To:	Commercial Real Estate Management, City of Toronto Metro Hall 2nd floor 55 John Street Toronto ON M5V 3C6	Addendum No:	05
		Project No:	21025 211018
Attention:	Bonita Lee	File No:	6-2-1
		Date:	November 28, 2024
		Pages (with cover):	22
Project:	Metro Hall Toronto Early Learning Child Care Centre	Delivery:	Electronic

1.1 Addendum No. 05

TORONTO
Metro Hall Fire Station &
Early Years Child Care Centre
Renovation

L1

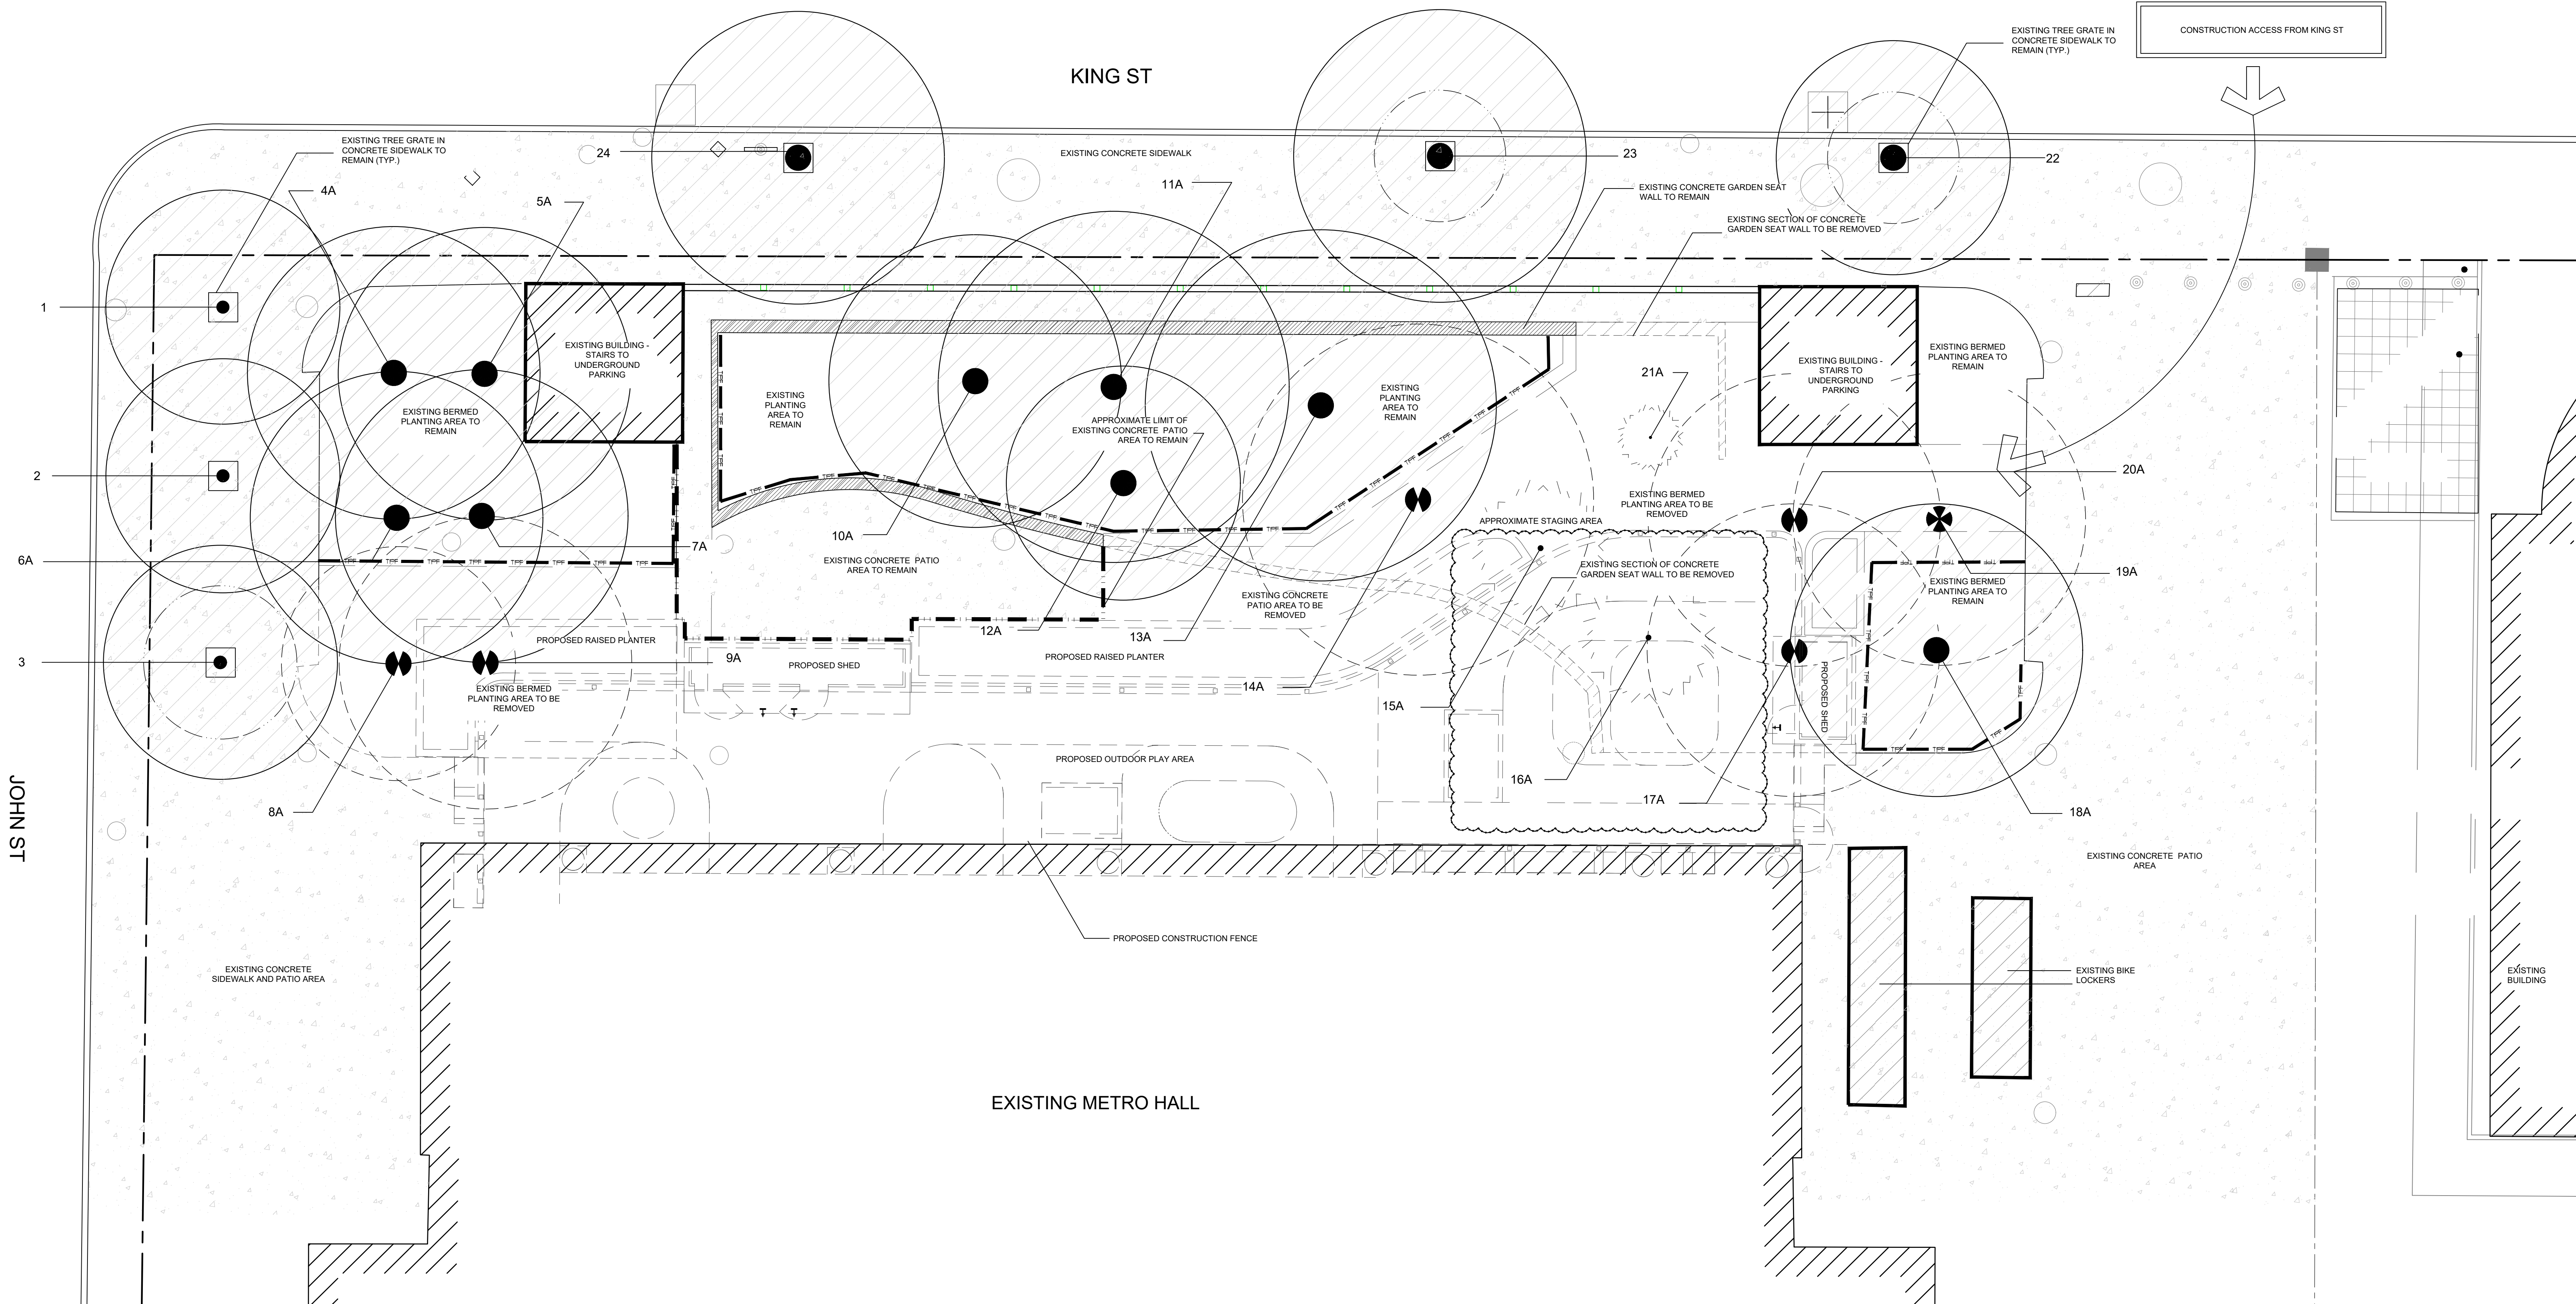
- 1. L1: revise tree protection plan to clarify scope of work.
- 2. L2: revise detail 3 as indicated.
